HYUNDAI Technical Service Bulletin	GROUP ENGINE MECHANICAL	NUMBER 26-EM-005H
	DATE FEBRUARY 2026	MODEL(S) SANTA FE (TMA)
SUBJECT: INTEGRATED THERMAL MANAGEMENT (ITM) REPLACEMENT & ECM/TCU SOFTWARE UPDATE – DTCS P218100, P2181F0, P2181F1

Description: Some Santa Fe (TMA) vehicles may have DTCs P218100, P2181F0, and/or P2181F1 (Cooling System Performance) set in the Electronic Control Unit (ECU), resulting in an illuminated Check Engine warning lamp. Follow the procedure in this TSB to replace the Integrated Thermal Management (ITM) module and update both the the Engine Control Module (ECM) and Transmission Control Module (TCM) if applicable. Follow the flowchart in this TSB to update the appropriate modules.

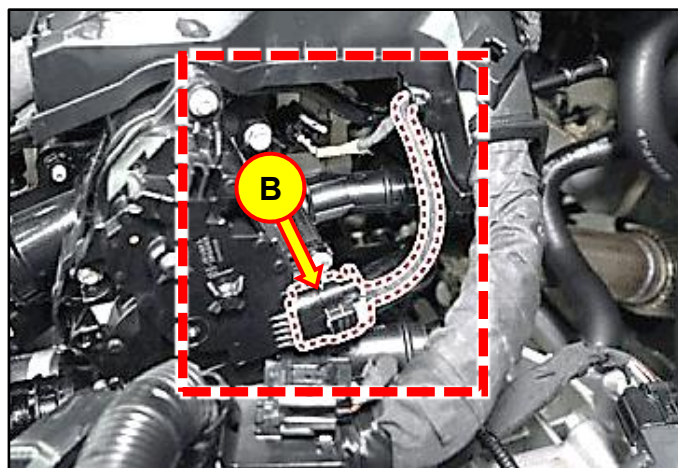
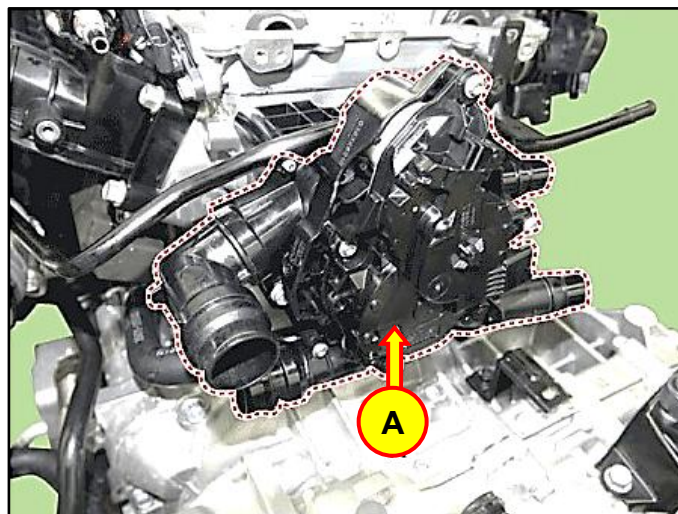
2. Replace the ITM (A) by referring to the shop manual.
 - **Engine Mechanical System > Cooling System > Integrated Thermal Management Module (ITM) > Repair procedures**
3. Reinstall parts in the reverse order of the removal process.

The ITM design inverts the connector's (B) orientation.
